ADDENDUM NO. 1

Re: WIP# 410A363

60' x 80' Storage Building at SDDOT Clear Lake Yard

STATE OF SOUTH DAKOTA	PROJECT	SHEET NO.	TOTAL SHEETS
	410A363	5	6
Plotting Date: 08/13/2015

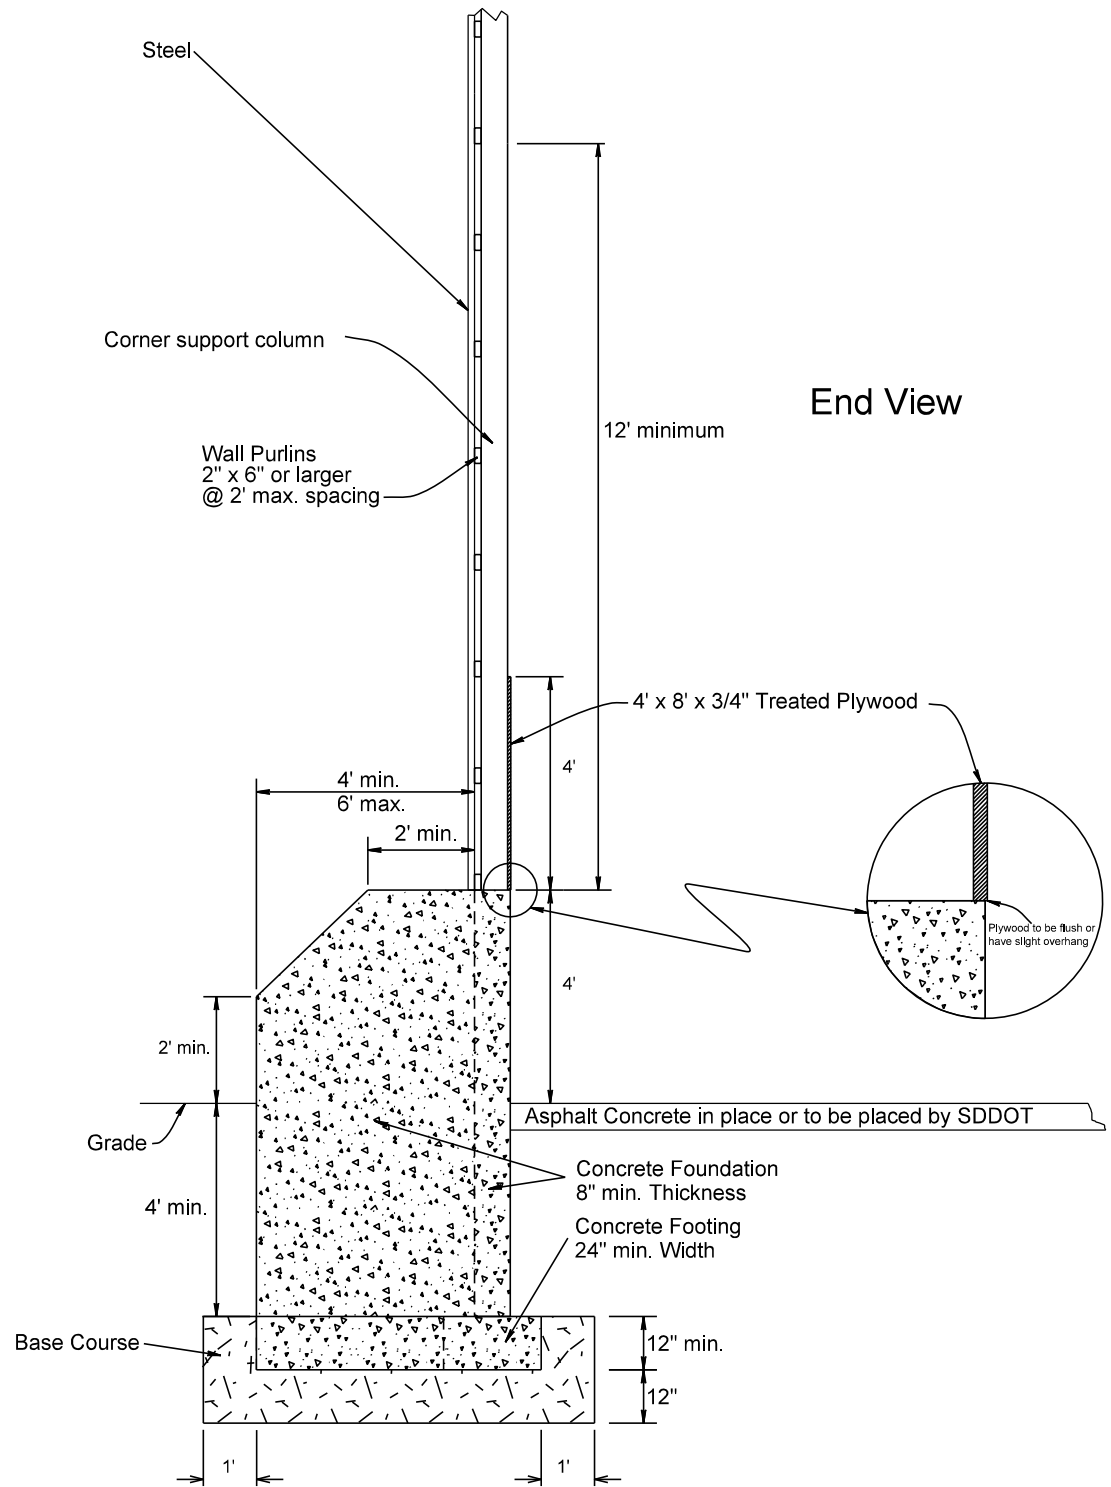
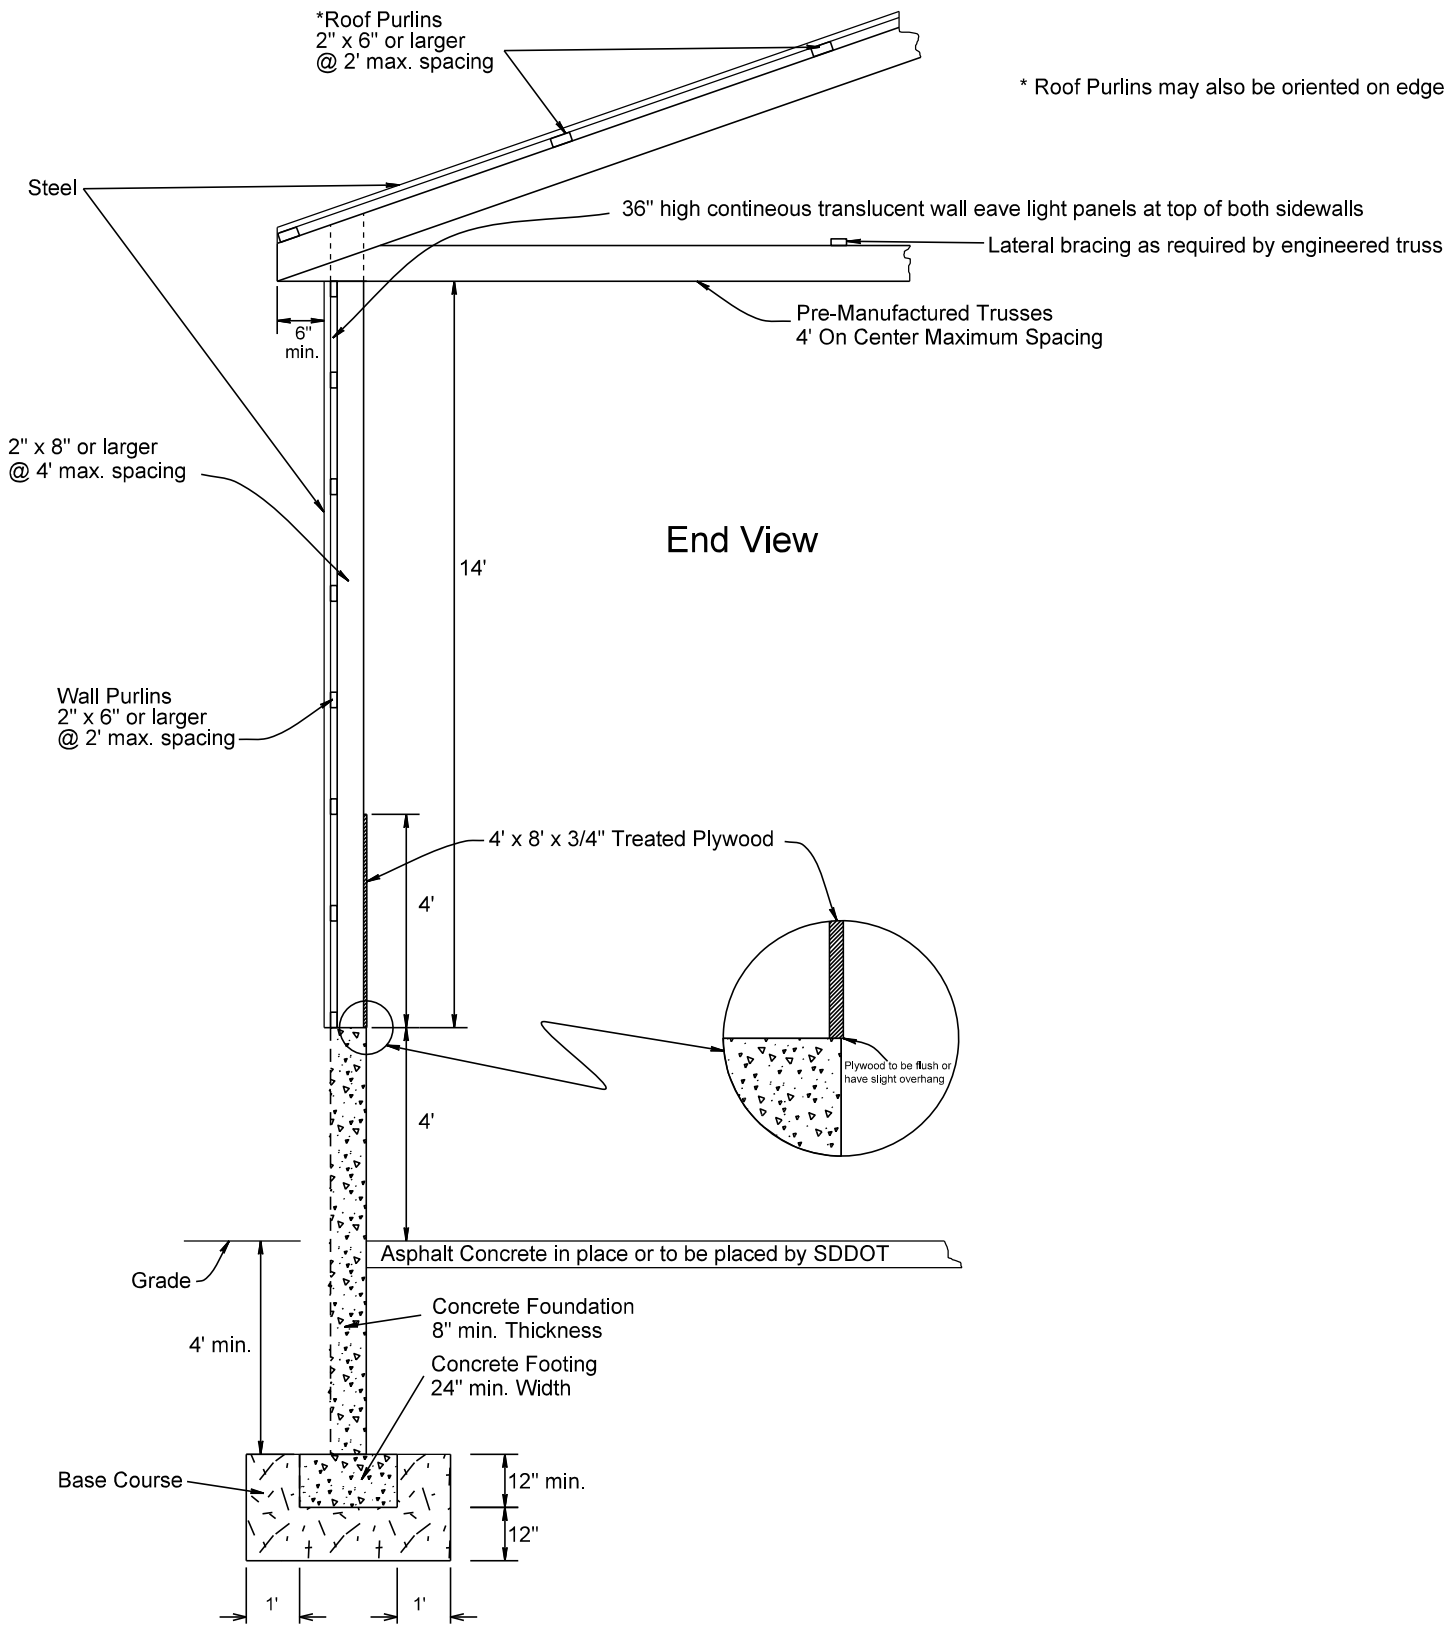
Sheet 5: The spacing of the trusses was revised and the header was removed. Added Roof Purlin options.

OPEN END
END SECTION

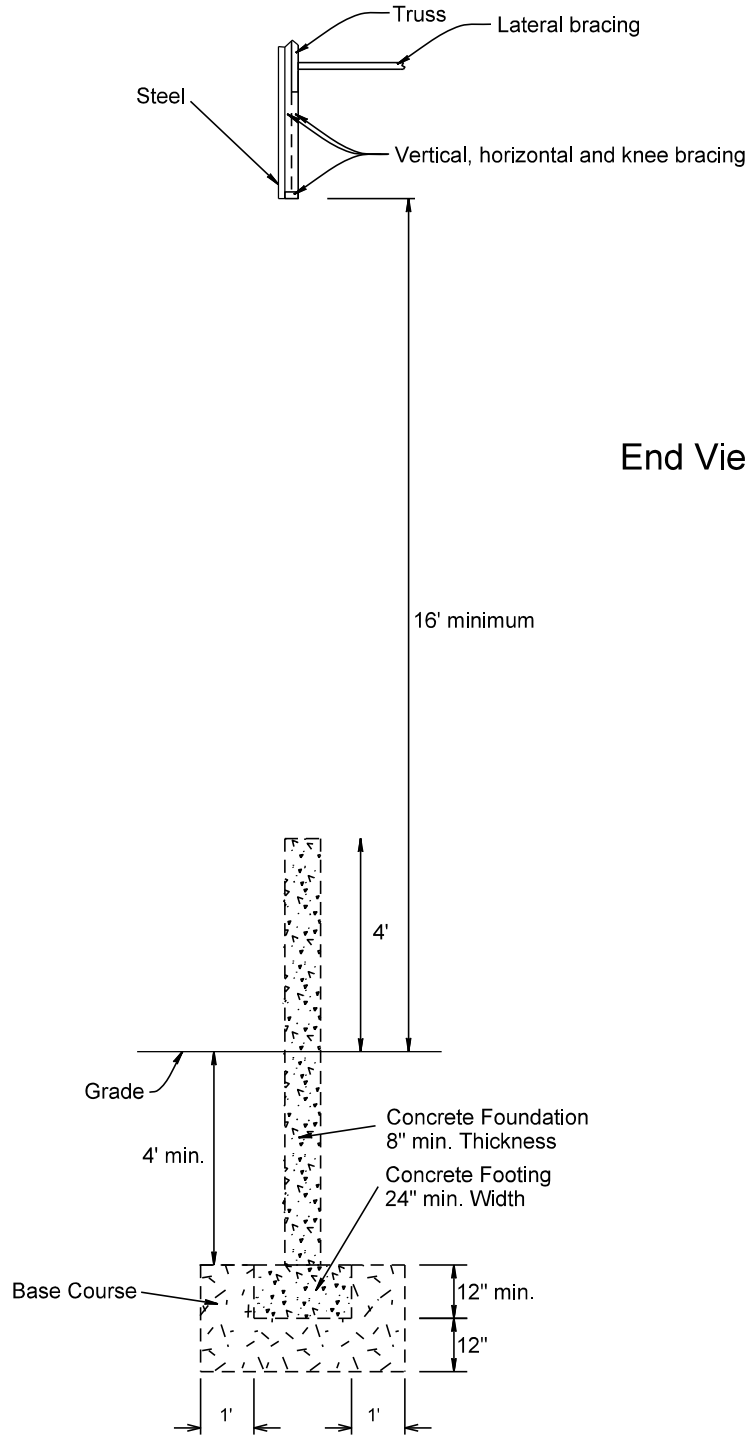
Sheet 6: The OPEN END END SECTION detail was revised eliminating the header.
